Development Application **ACCESS REPORT**

Reference Number: 22440

Site Address: 14 Windermere Avenue, Northmead NSW

Executive Summary and Design Compliance Statement

[Image description: Plan of Ground Level above shows the provision of Accessible parking spaces]

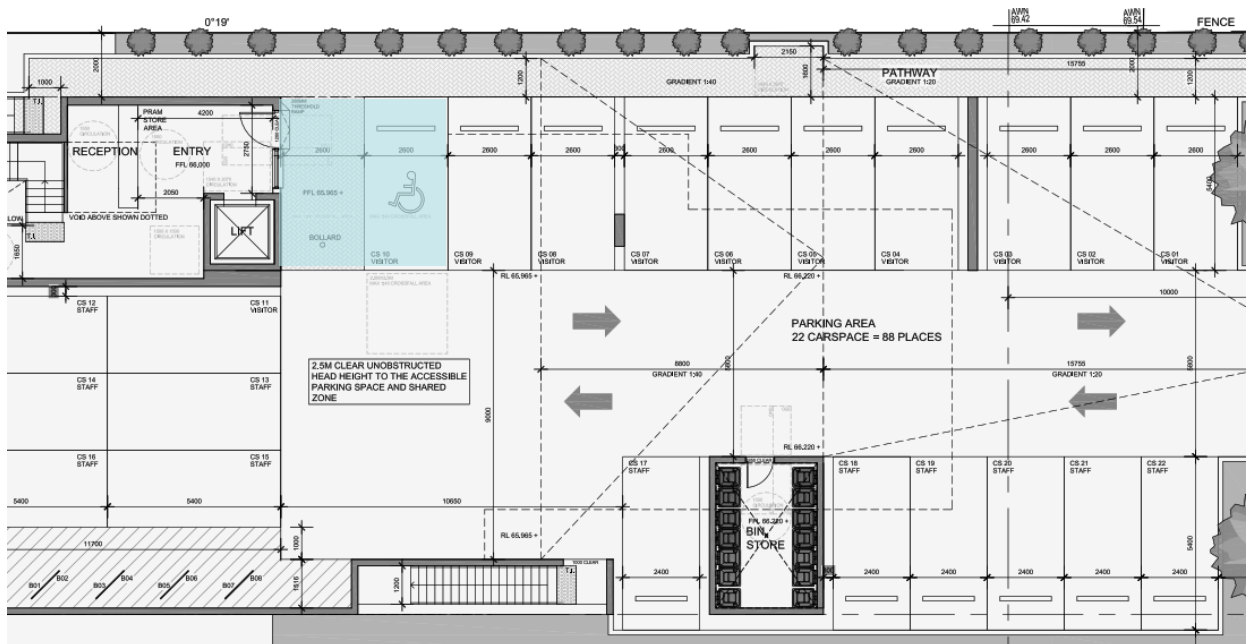
Total number of Accessible parking spaces required / provided in the development = 1

Ground

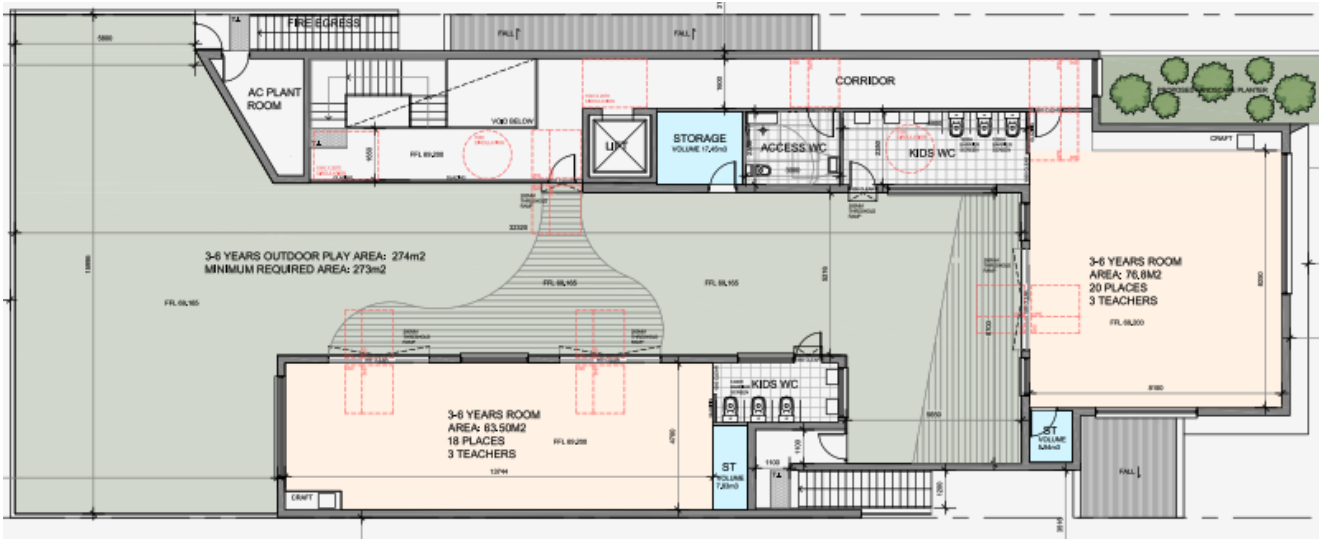
3 accessible toilets have been provided in the development.
